SERVICE BULLETIN

M-903

SERVICE UPDATE GENERAL INFORMATION

Cylinder Heads and Cylinder Studs 1985 Big Twin Evolution™ Engines (See Figure 1)

Figure 1. Cylinder Stud and Head Screw

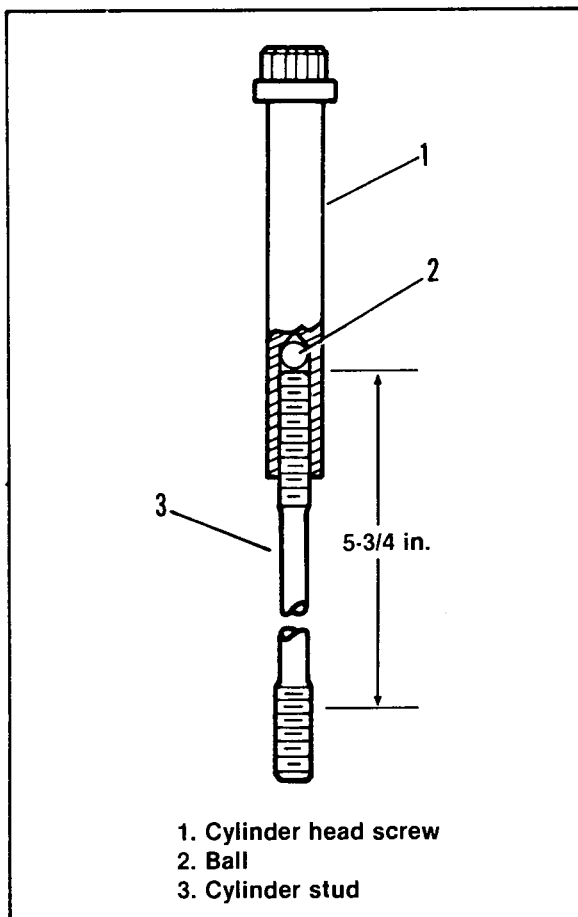
Big Twin Evolution™ engines are now using a cylinder stud (3) with male threads at both ends. The mating cylinder head screw (1) has female threads. Because of the internal threads the head screw was made a larger diameter.

The 1985 cylinder heads are interchangeable with either style cylinder studs and head screws.

Late style cylinder head washers cannot be used with early style head screws.

1. Remove bent or damaged cylinder studs with a stud remover.
2. The top end of the stud (cylinder head end) will have a number "3" stamped on the stud end. Measure 5-3/4 in. from the top of the stud toward the bottom of the stud. Paint a line on the threads to indicate the 5-3/4 in. measurement. This painted area will be used as a reference during installation.
3. Place 5/16 in. diameter ball, Part No. 8860 from the XL clutch release mechanism into the head screw recess. Thread the stud into the head bolt until the stud bottoms on the ball.
4. Clean the threads in the crankcase. Apply Loctite Stud'N Bearing Mount on the stud threads.

Use an air or electric impact wrench and install the stud threads to the depth of the painted line.
5. Pack clean shop towels into the crankcase openings to prevent the ball from falling into the fly-wheel compartment when removing the head bolt.
6. With a dial caliper verify that installed stud has a depth of 5.670 - 5.770 in. above the base gasket surface.

Figure 2. Torquing Sequence

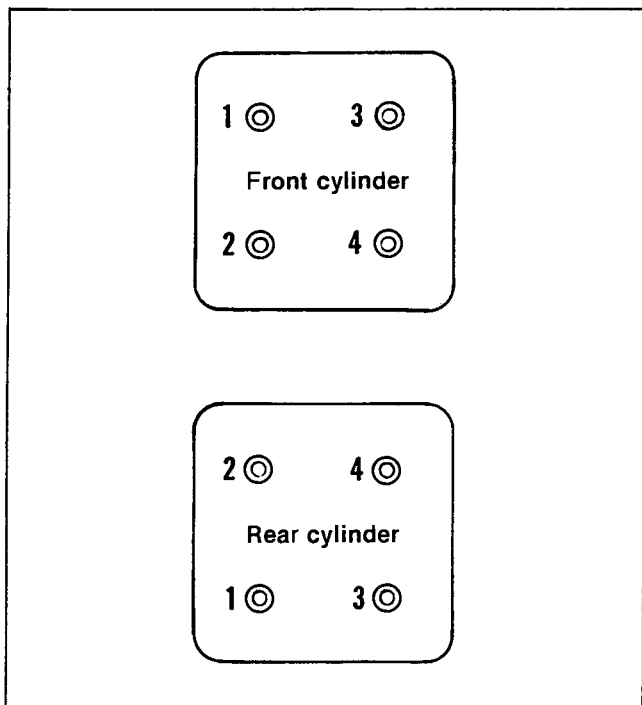
and cylinder head, a new torquing procedure has been developed. The new torquing method eliminates much of the frictional losses which contributed to erratic distribution of head clamping pressures. This new method is applied to all 1340 Evolution™ engines equipped with either style cylinder studs and head screws.

1. Refer to Figure 2. With a torque wrench start at the head screw numbered "1" and tighten to a torque of 7 ft lbs. Then proceed to tighten "2", then "3" then "4", in order, to 7 ft lbs torque.
2. Again starting at the head screw numbered "1" and ending with "4" sequentially, tighten each screw to 16 ft lbs torque.
3. Refer to Figure 3. Mark a line on the cylinder head and a corresponding line on the head of the cylinder head screw as shown in View A. Following the same sequence 1, 2, 3, then 4, turn each head screw, one at a time one quarter turn (90°) using the marks as a guide. When marks are all positioned as in View B the procedure is completed.

Figure 4. Ground Cable Mounting

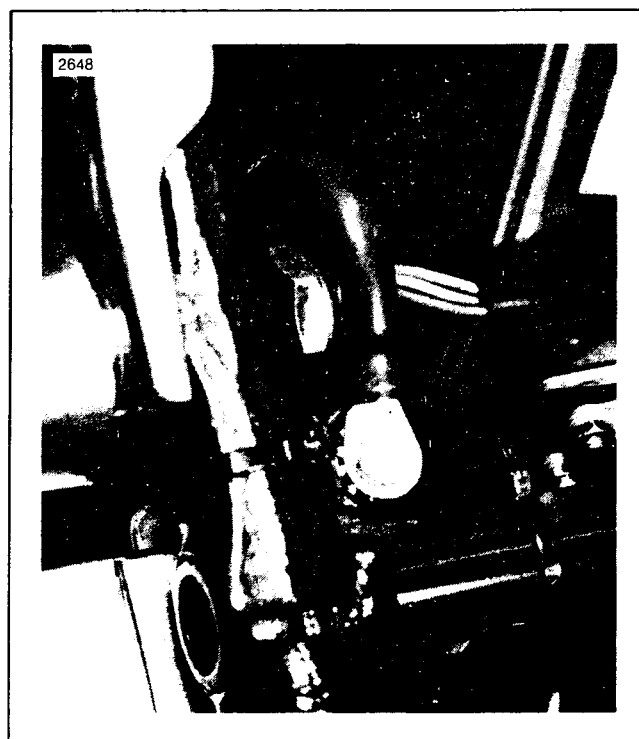
Ground Cable All FX Vehicles Excluding FXST (See Figure 4)

It is important that the ground cable on FX vehicles, excluding FXST, are formed and mounted to prevent contact with the rear fender or frame. With the cable loop free to vibrate there is no vibration transmitted to the cable ends which could cause premature failure at the mounting lugs. Be sure the mounting bolts at battery and frame are tightened to hold cable securely. Check the ground cable whenever servicing FX vehicles.
